Mayberry, Colorado Springs

Filing No. 3

Construction Drawings

MAYBERRY, COLORADO SPRINGS - FILING NO. 3

Pedestrian Intersection Ramp Standard Drawing DATE APPROVED: 7/9/09, FILE NAME: SD_2-41

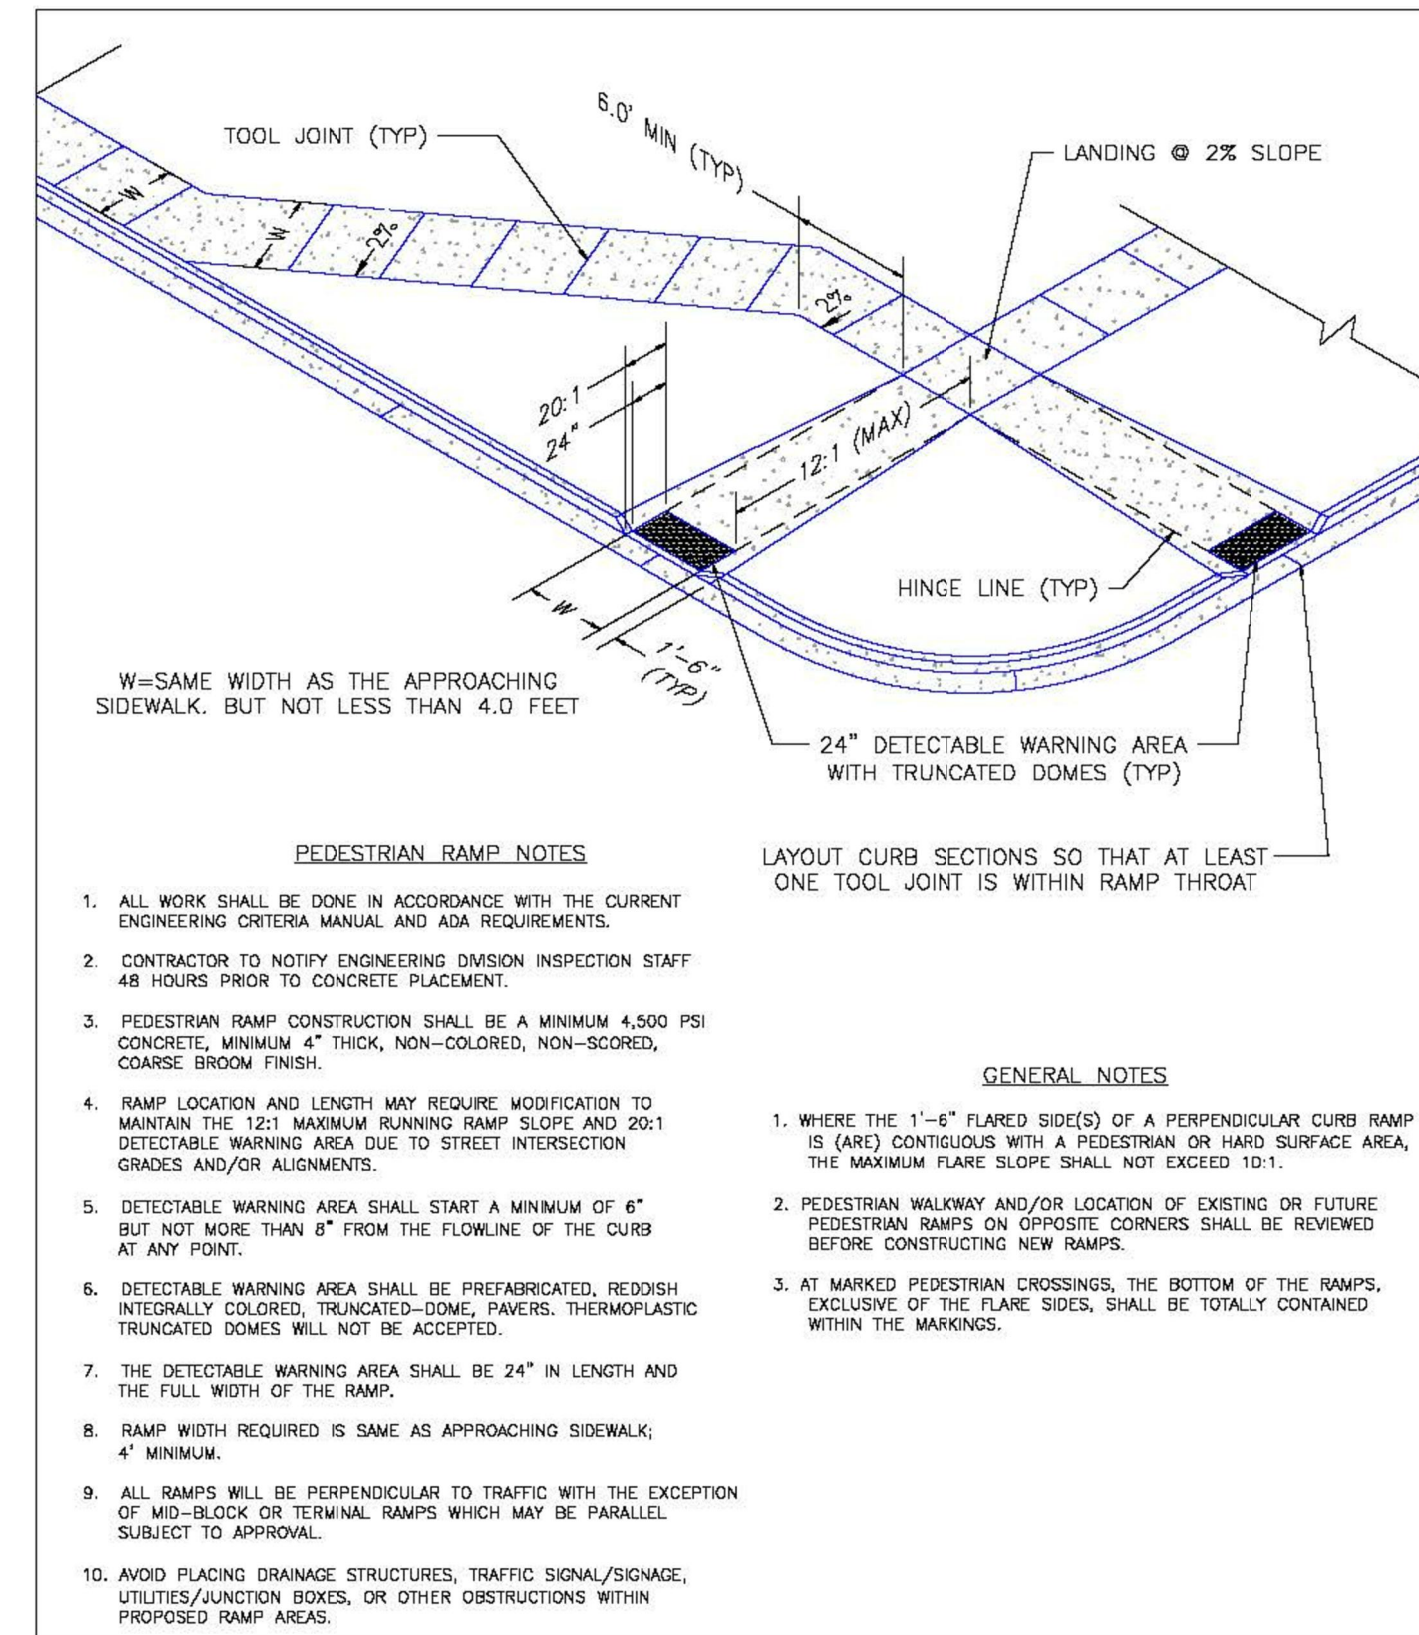
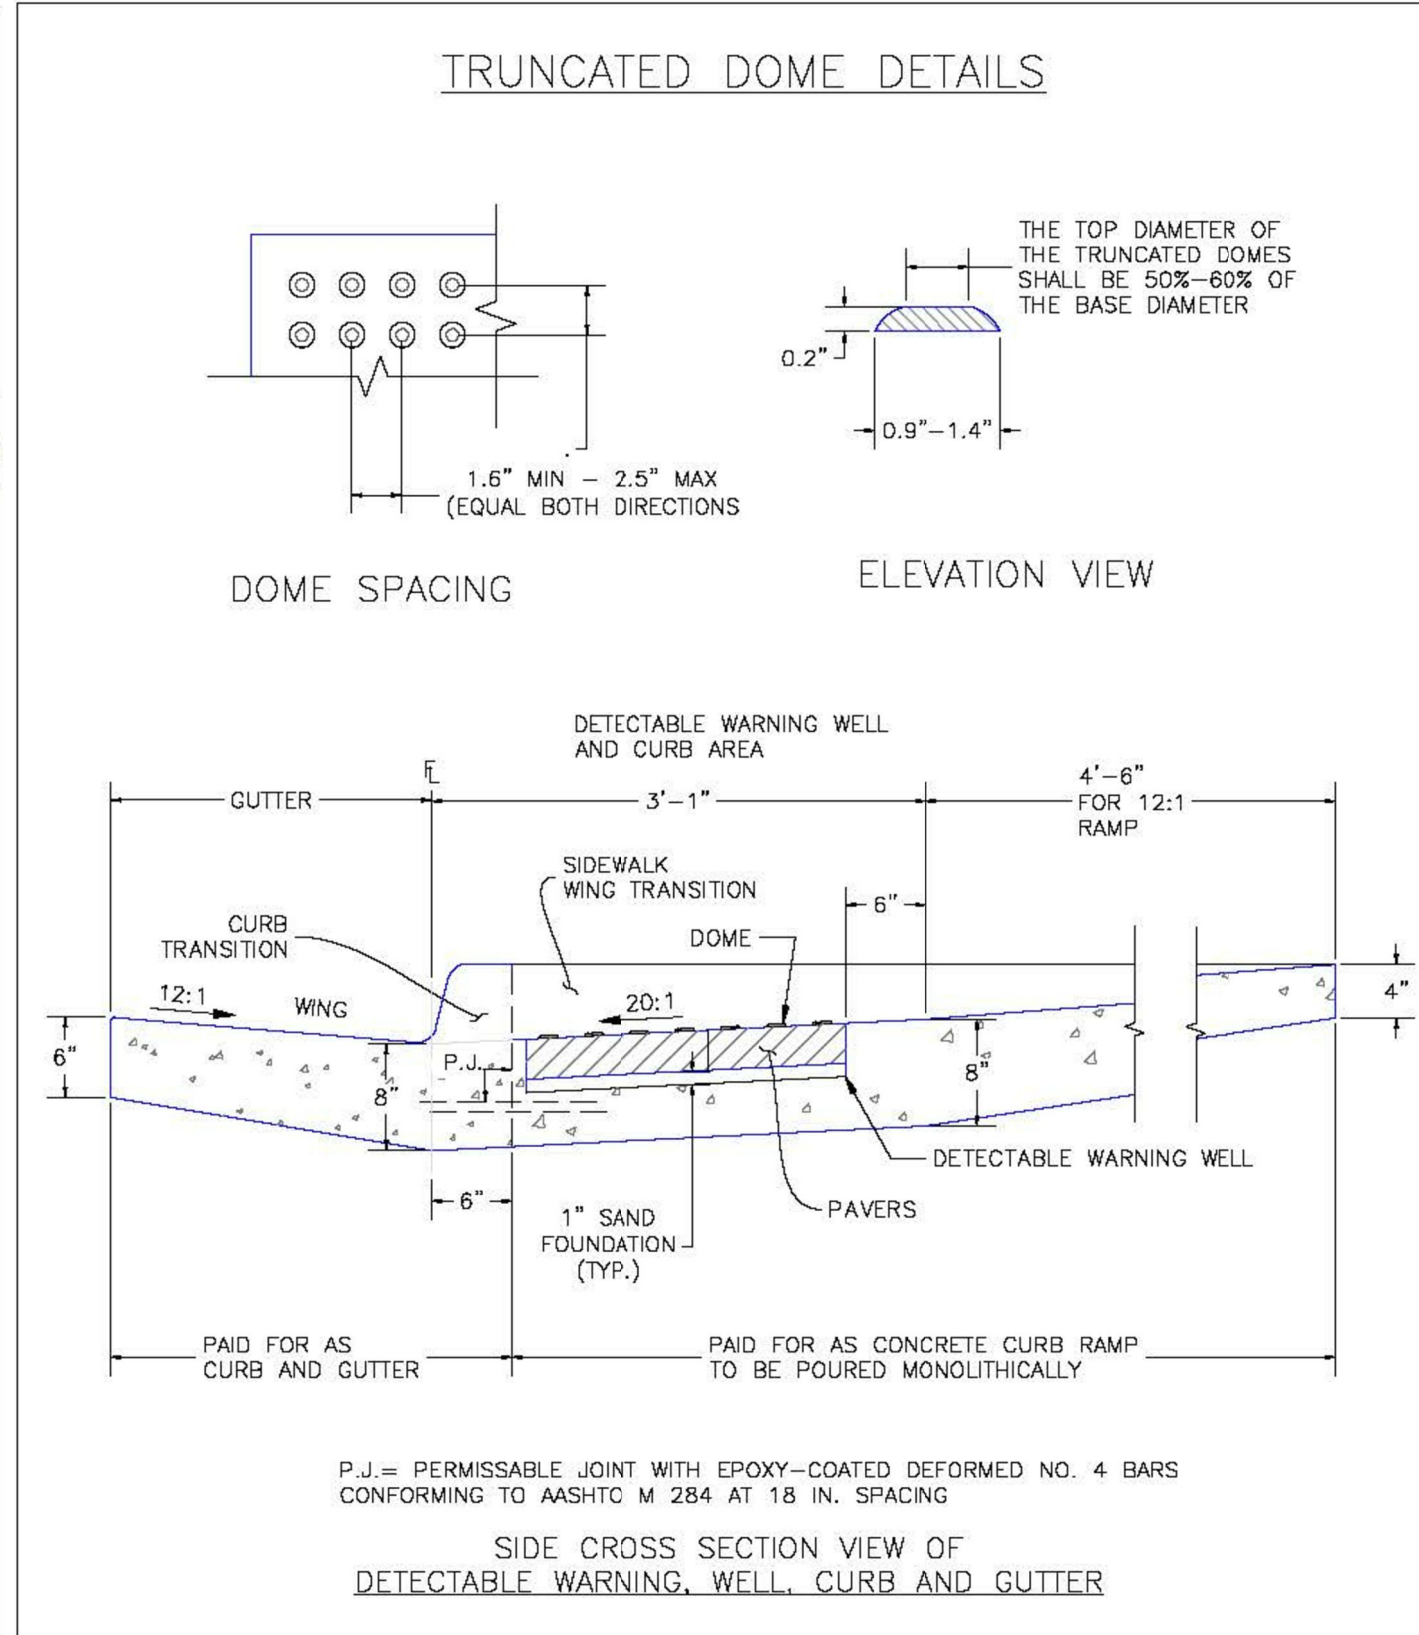
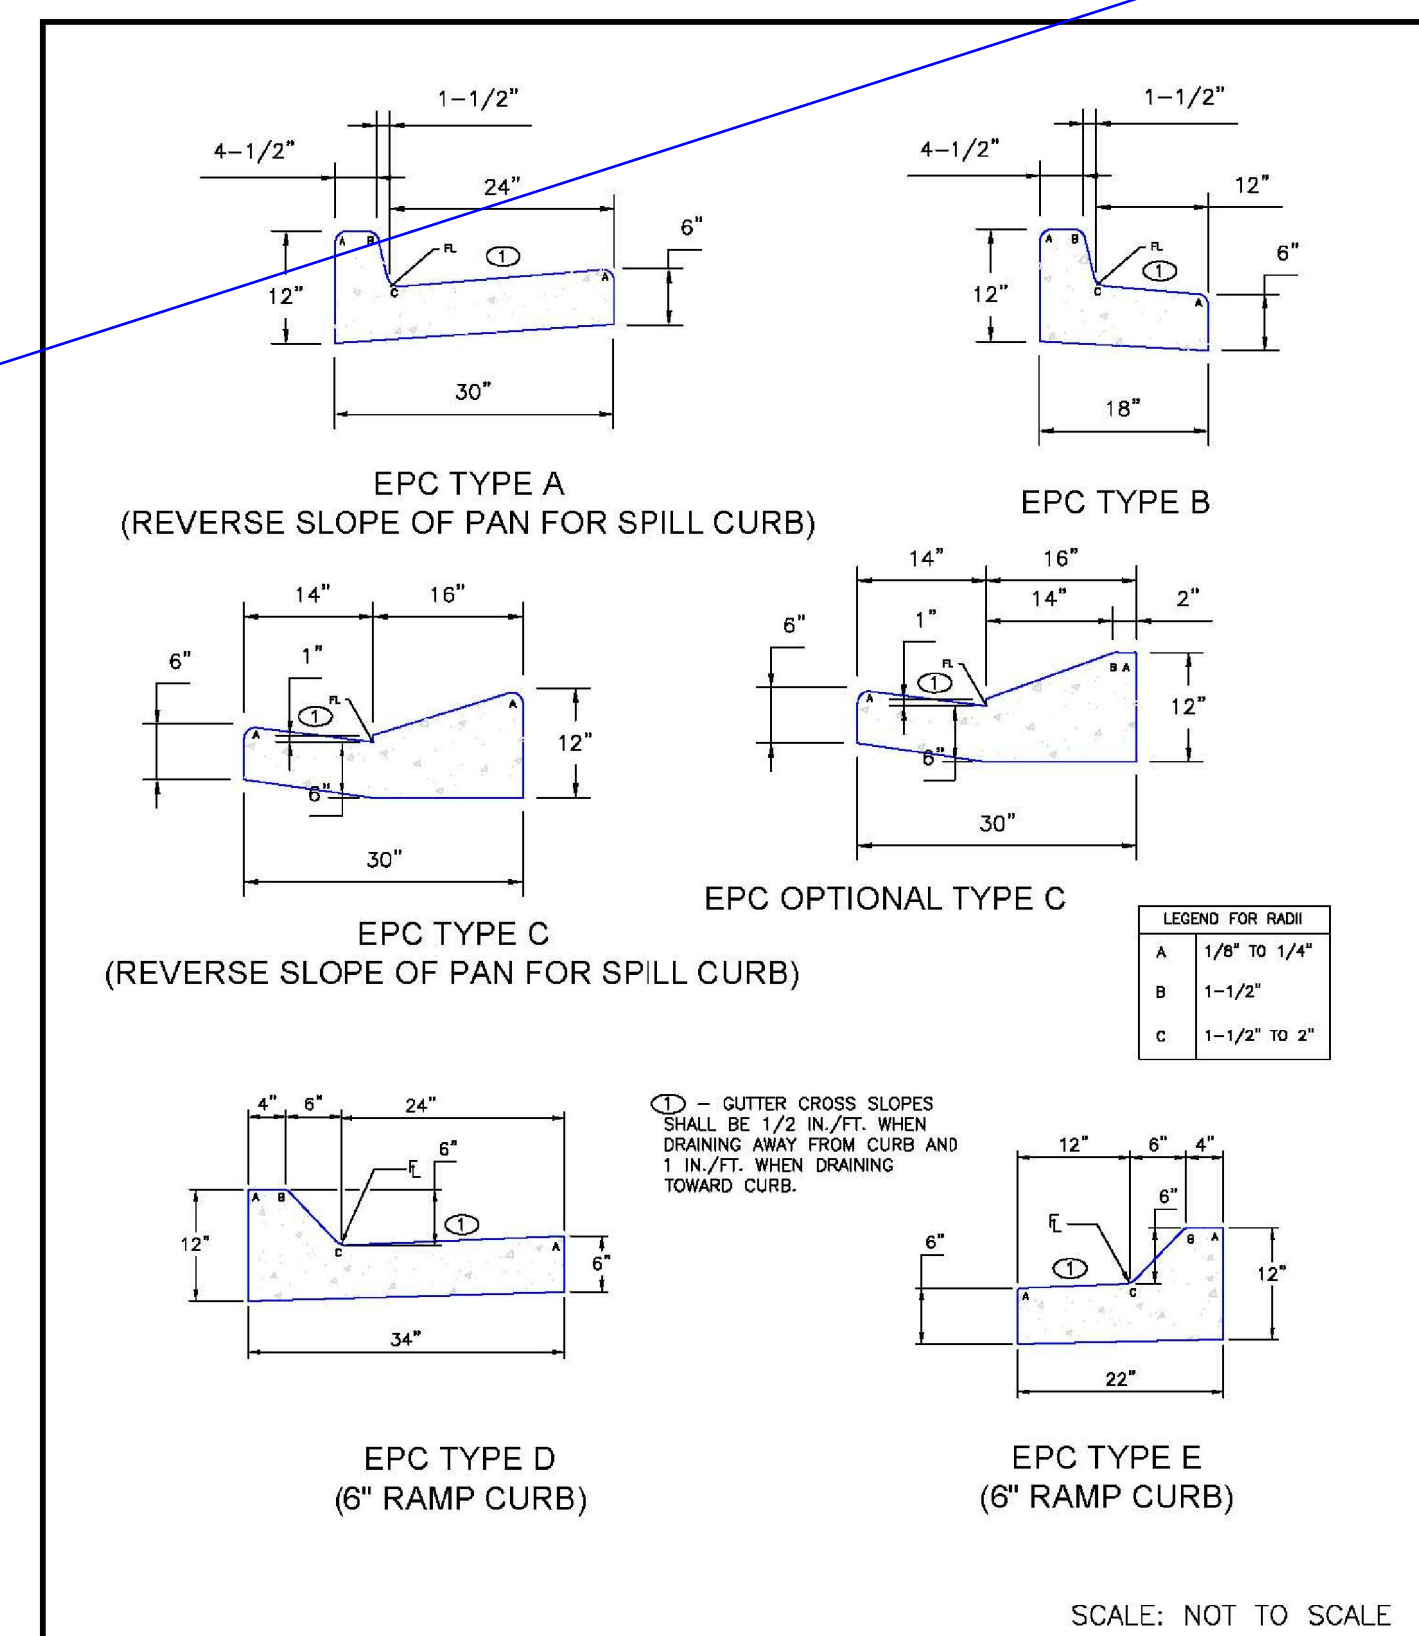
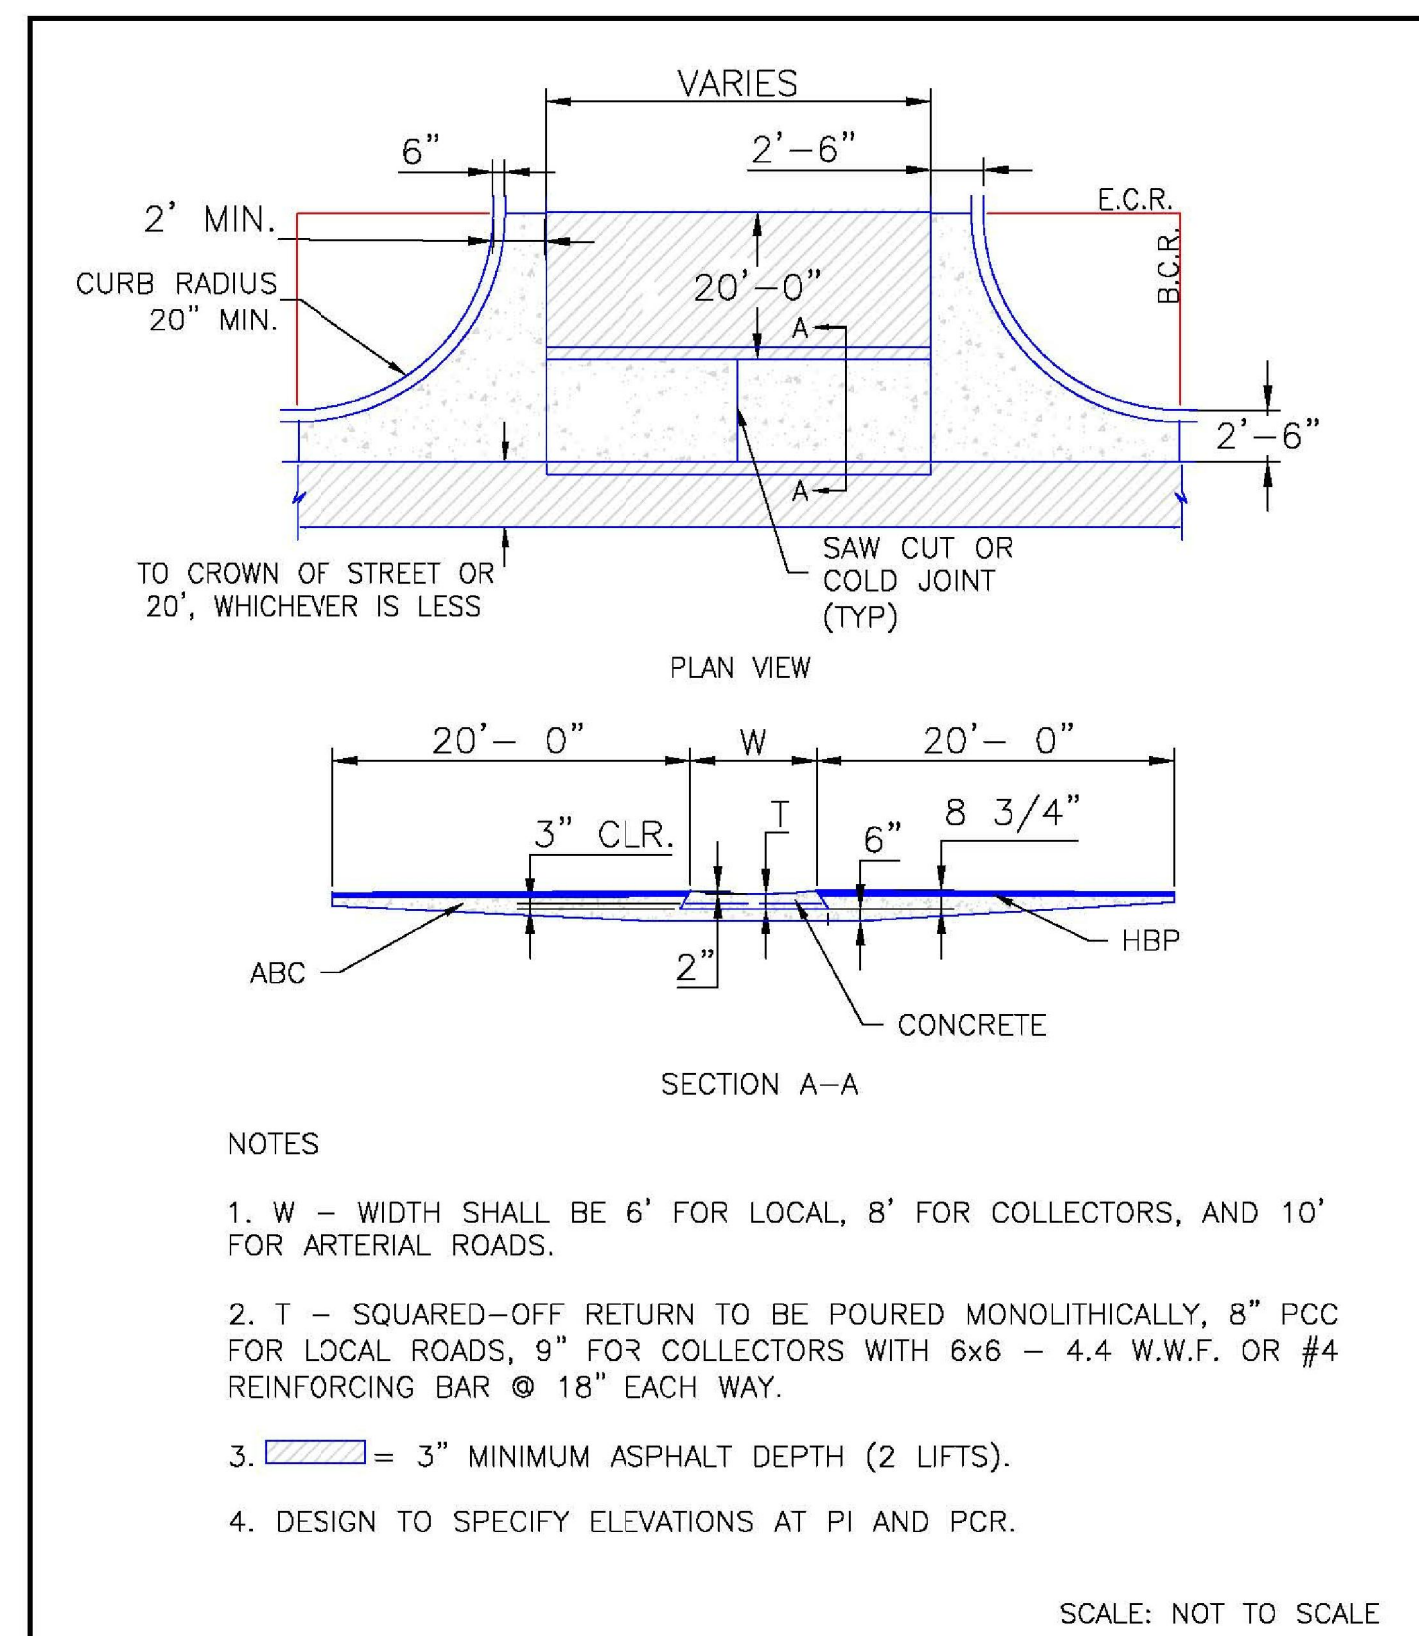
Update details to latest versions.
